EASTERN AVENUE
104-P-32-33

APPLICATION FOR PERMIT

To construct $1\frac{1}{2}$ story frame cottage 24'x28'.

Subject: Application for 1½-story wood frame
cottage on Eastern Avenue, Long Island,
Assessors Lot No. 104-S-32 and 33

104-H

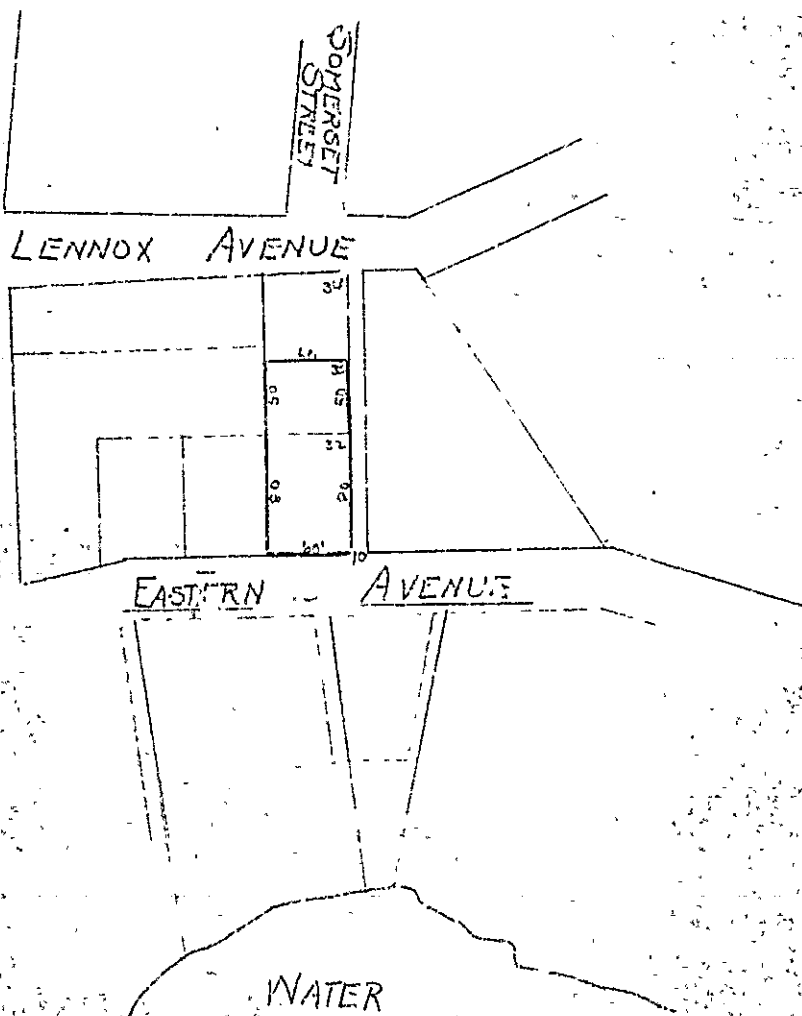
✓ 6x6 sill does not figure out on 7' span

✓ 6x8 girders must be on edge and have same no of piers as sills

Concrete piers 4' below grade on to ledger
How are ceiling timbers to be supported
across living room where there is no
✓ ceiling partitions

Use 6x8
